COVER SHEET  
CIVIL PLANS

240 15TH STREET SE  
PUYALLUP, WA 98372

**FORTRESS - PUYALLUP**

# CIVIL TESC AND DEMOLITION PLAN

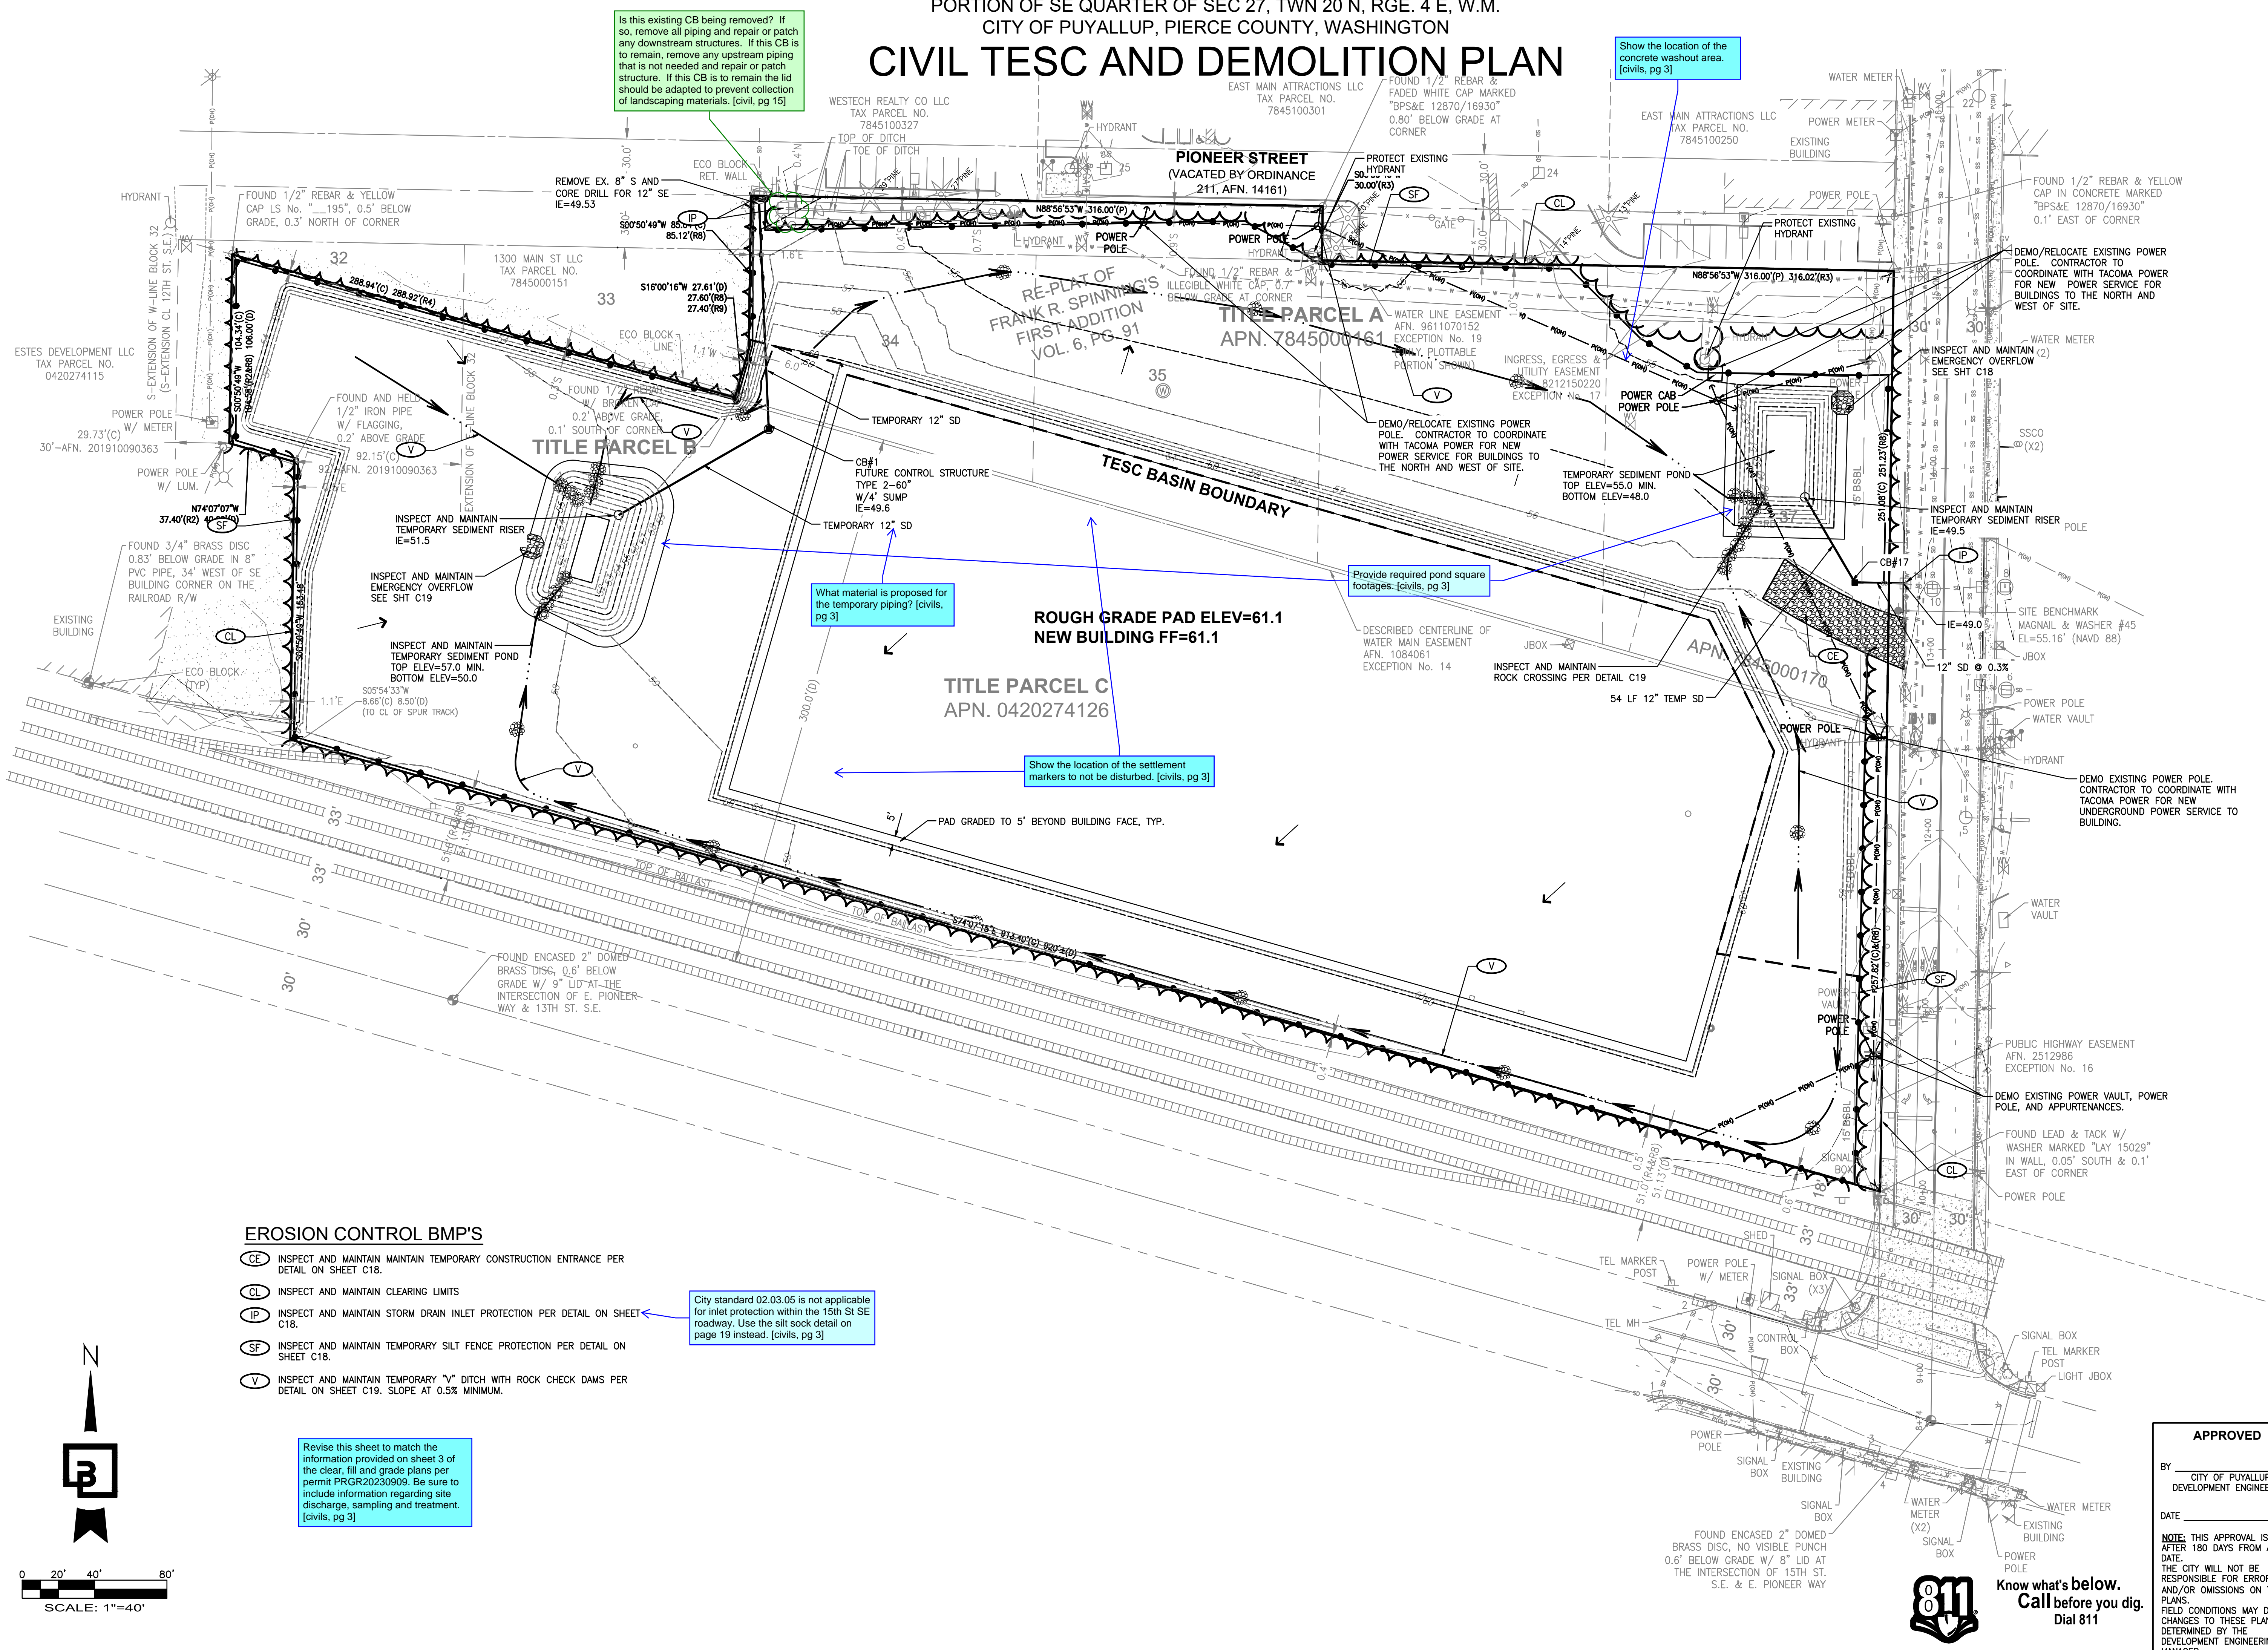
City standard 02.03.05 is not applicable for inlet protection within the 15th St SE roadway. Use the silt sock detail on page 19 instead. [civils, pg 3]

Revise this sheet to match the information provided on sheet 3 of the clear, fill and grade plans per permit PRGR20230909. Be sure to include information regarding site discharge, sampling and treatment. [civils, pg 3]

# WATER AND SANITARY SEWER PLAN

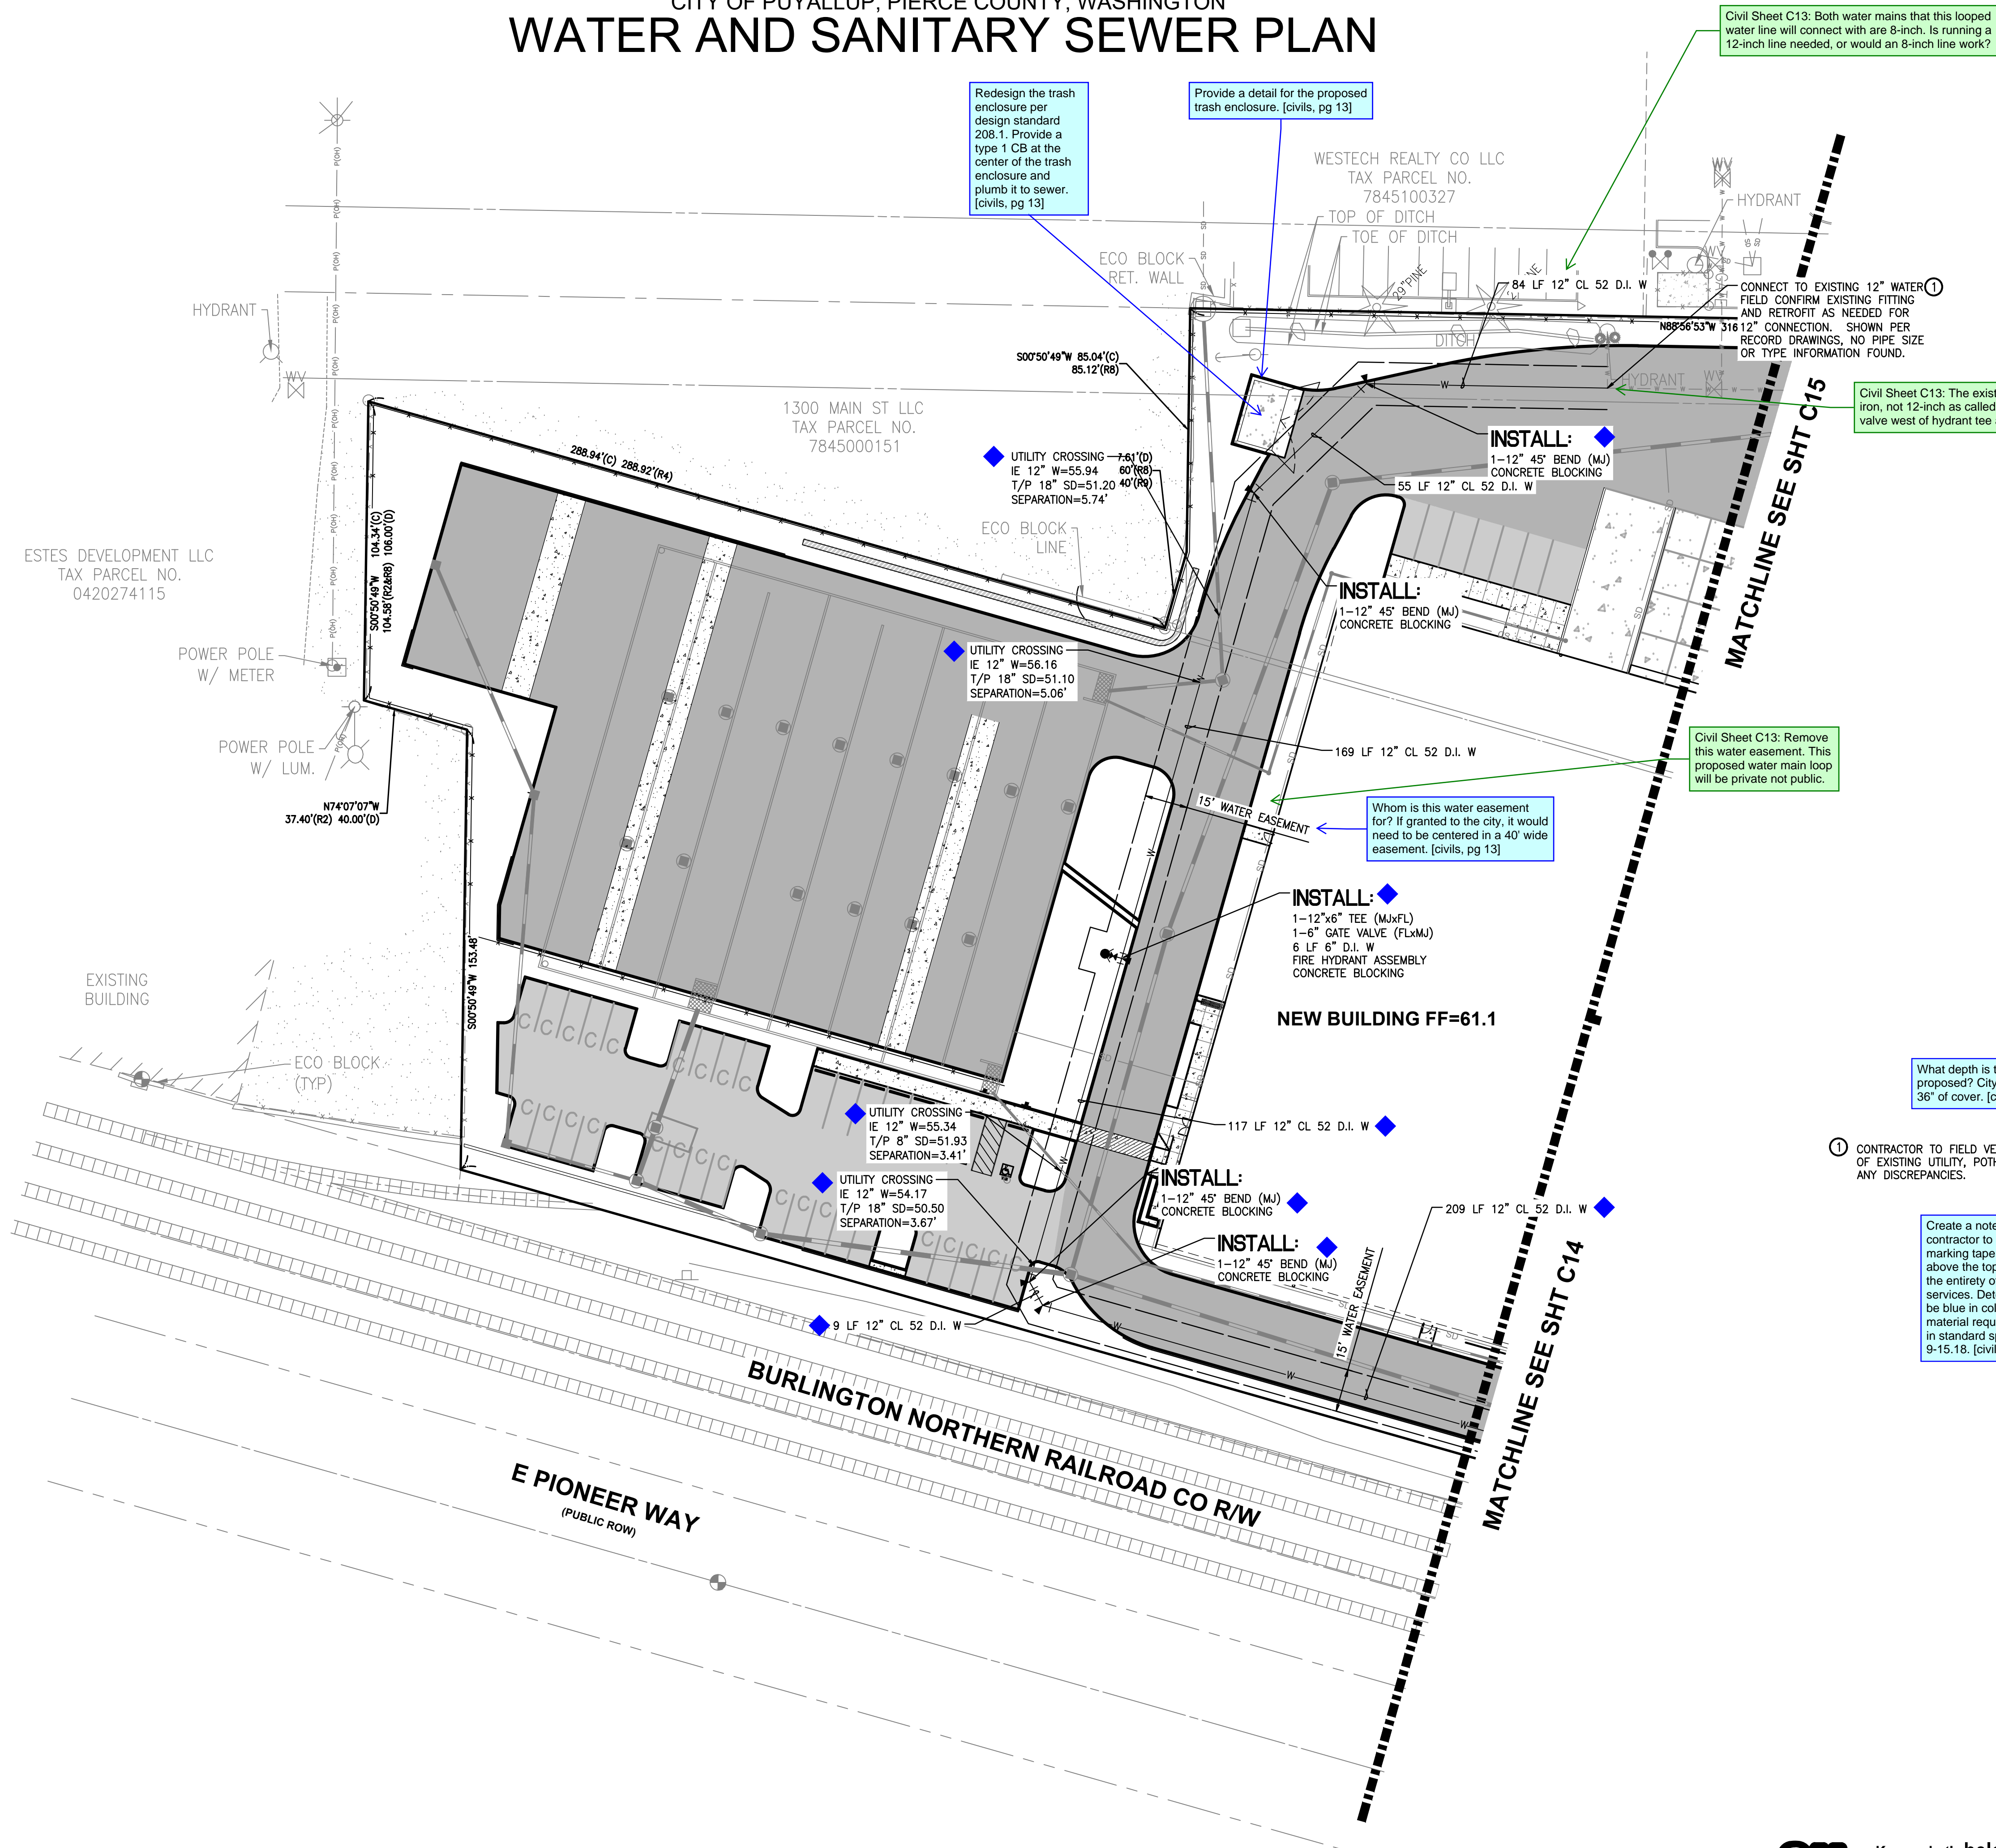
Redesign the trash enclosure per design standard 208.1. Provide a type 1 CB at the center of the trash enclosure and plumb it to sewer. [civils, pg 13]

Provide a detail for the proposed trash enclosure. [civils, pg 13]

Civil Sheet C13: Both water mains that this looped water line will connect with are 8-inch. Is running a 12-inch line needed, or would an 8-inch line work?

Civil Sheet C13: The existing water main is 8-inch ductile iron, not 12-inch as called out. Install a new 8-inch gate valve west of hydrant tee at connection point.

Provide a draft easement for the water main per the following link: <chrome-extension://efaidnbmnnnibpcajpcglclefindmkaj/https://www.cityofpuyallup.org/DocumentCenter/View/7331/Appendix-C-7bid> [civils, pg 13]

Civil Sheet C13: Remove this water easement. This proposed water main loop will be private not public.
